**PLANNING APPROVAL,
PLANNED UNIT DEVELOPMENT, &
SUBDIVISION STAFF REPORT****Date: November 5, 2015**

<u>DEVELOPMENT NAME</u>	The Village Subdivision
<u>SUBDIVISION NAME</u>	The Village Subdivision
<u>LOCATION</u>	1204 Hillcrest (West side of Hillcrest Road at the West terminus of Omni Park Drive)
<u>CITY COUNCIL DISTRICT</u>	Council District 6
<u>AREA OF PROPERTY</u>	1 Lot / 4.8 ± Acres
<u>CONTEMPLATED USE</u>	Planned Unit Development Approval to allow multiple buildings on a single building and shared access, Planning Approval to allow the expansion of an existing church in an R-3, Multiple Family District, and Subdivision approval to create one legal lot of record.
<u>TIME SCHEDULE FOR DEVELOPMENT</u>	None given.
<u>ENGINEERING COMMENTS</u>

SITE PLAN

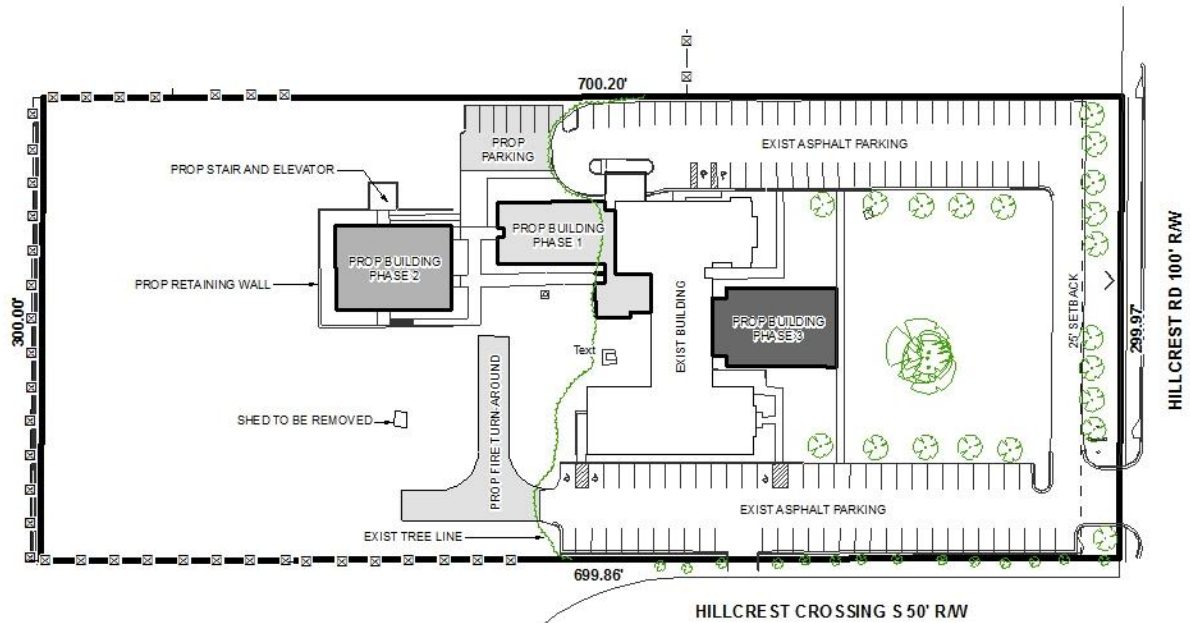
Site is limited to no more than one curb-cut per street frontage. The existing Hillcrest Road curb-cut should be closed, as it is an uncontrolled driveway within a signalized intersection. The driveway to Hillcrest Crossing South should be improved to a City standard commercial driveway. Any new on-site parking, including ADA handicap spaces, shall meet the minimum standards as defined in Section 64-6 of the City's Zoning Ordinance.

The total amount of proposed tree plantings and landscaping calculations are illustrated on the site plan. However, it appears that the total perimeter tree credit calculations provided cannot be verified or reproduced by staff. Although it appears that full tree and landscaping compliance is possible, staff cannot accurately determine the total number of tree credits based on the plan submitted. The site plan should be in full compliance with Section 64-4.E of the Zoning Ordinance.

The site plan depicts 121 parking spaces therefore providing a compliant amount of parking spaces on site. However, the site lists 114 parking spaces under the “Tree” column referencing required trees (parking lot). The site plan should be revised to utilize the actual number of spaces provided.

The site plan depicts a wooden fence along the sides and rear of the site but does not indicate the height of the fence. Due to the fact the site abuts residential zoned property a 6’ high wooden privacy fence as well as a 10’ minimum residential buffer will be required where the site abuts residential property, at the time of the first phase of development. The site plan should be revised to depict both the 6’ high wooden privacy fence as well as a 10’ minimum residential buffer.

There is no dumpster illustrated on the site plan, nor is there a note stating that curbside pickup will be utilized. If approved, the site plan should be revised to either illustrate all existing and proposed dumpsters with new dumpsters to be in compliance with Section 64-4.D.9. of the Zoning Ordinance, or place a note stating that curbside service or some other service will be utilized.

- 1) revision of the site plan to reflect Traffic Engineering comments: “*Site is limited to no more than one curb-cut per street frontage. The existing Hillcrest Road curb-cut should be closed, as it is an uncontrolled driveway within a signalized intersection. The driveway to Hillcrest Crossing South should be improved to a City standard commercial driveway. Any new on-site parking, including ADA handicap spaces, shall meet the minimum standards as defined in Section 64-6 of the City’s Zoning Ordinance.*”;

- 2) revision of a 10’ minimum building setback line where the site abuts residential zoned property;
- 3) revision of site plan to depict perimeter tree credit calculation’s in compliance with Section 64-4.E of the Zoning Ordinance;

- 4) revision of site plan to depict a 6’ wooden privacy fence where the site abuts residential property, at the time of the first phase of development;

- 5) revision of the site plan to depict the same number of required trees under both the “trees” and “landscaping” columns;

- 6) revision of the site plan to depict all existing and proposed dumpsters with new dumpsters to be in compliance with Section 64-4.D.9. of the Zoning Ordinance, or place a note stating that curbside service or some other service will be utilized.
